File No. 43 of 1898.

Construction of plague sheds at the Taluk
Headquarters and near railway stations.

TYPE PLAN OF PLAGUE SHEDS WITH THATCHED ROOF *Scale 4'-1"*

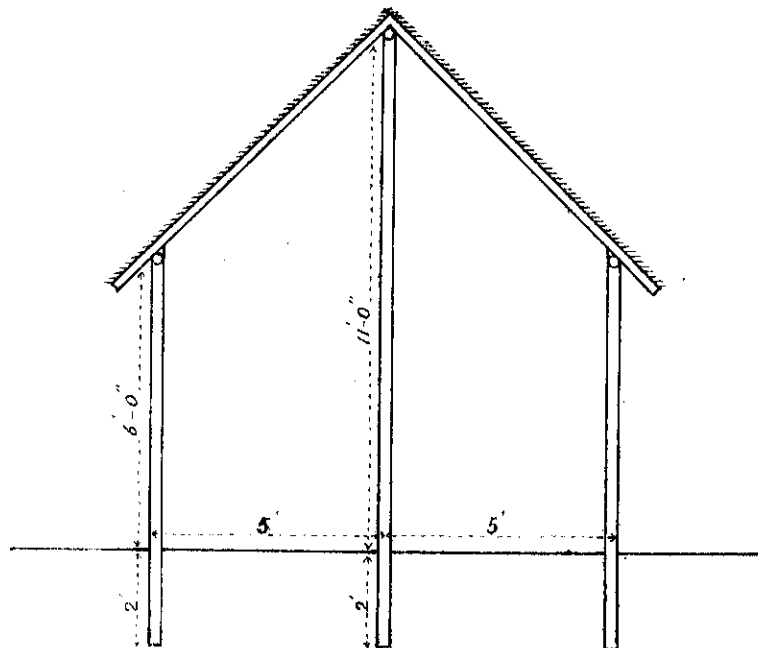
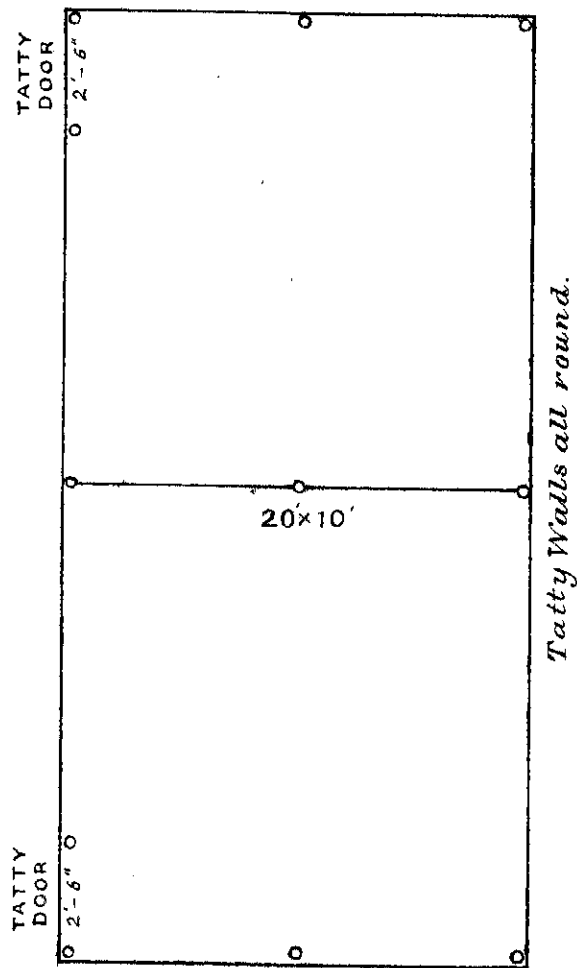
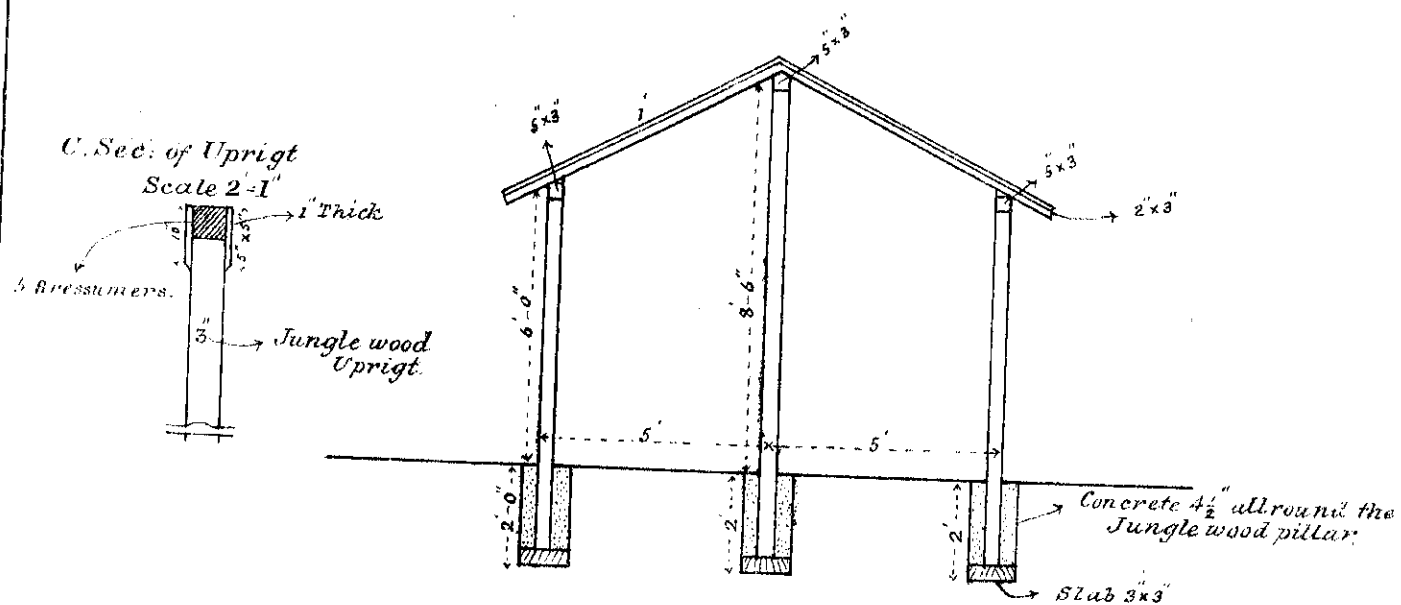
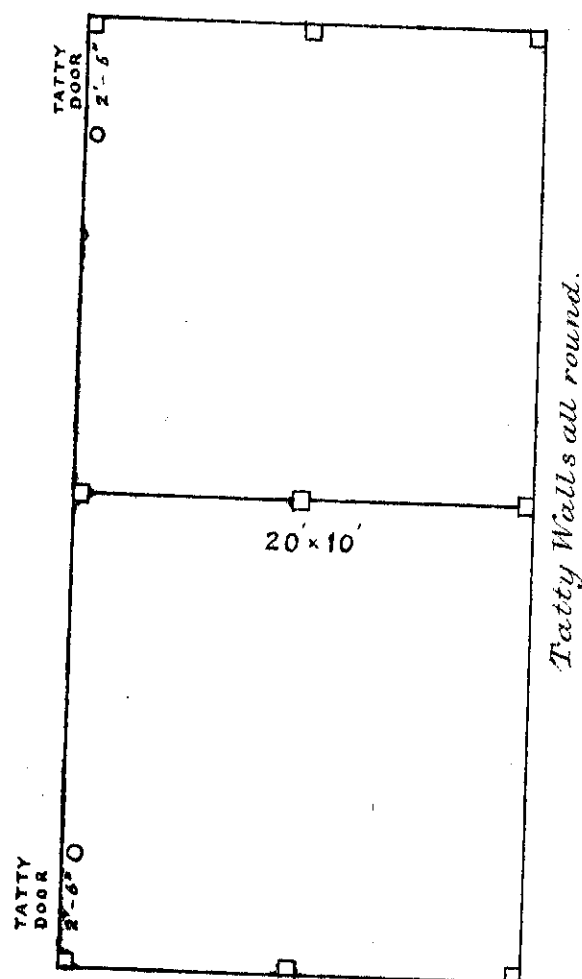
work to keep up with
but the estimate
seems very heavy

This may be shown unofficially
to Mr. Ranga Rao whose
opinion on the estimates
may be obtained

Has the honor to
return the plan &
estimates received
with the above for
favor of their being
revised in accordance
with instructions
contained in this Office
Circular No 1315-22
of the 29th instant

Has the honor to forward herewith two type plans and estimates as per details in the margin for the construction of plague sheds. These plans may be adopted wherever plague sheds have to be constructed. Abstract estimates with the columns for rates filled in need only be submitted to this office for sanction. The number of sheds may be regulated according to local requirements. Sheds with corrugated iron roof are preferable, the thatched roof being adopted only in places where corrugated iron cannot be easily procured.

2. Tatty walls will generally do except in the Malnad where corrugated iron may be used for the sides also.
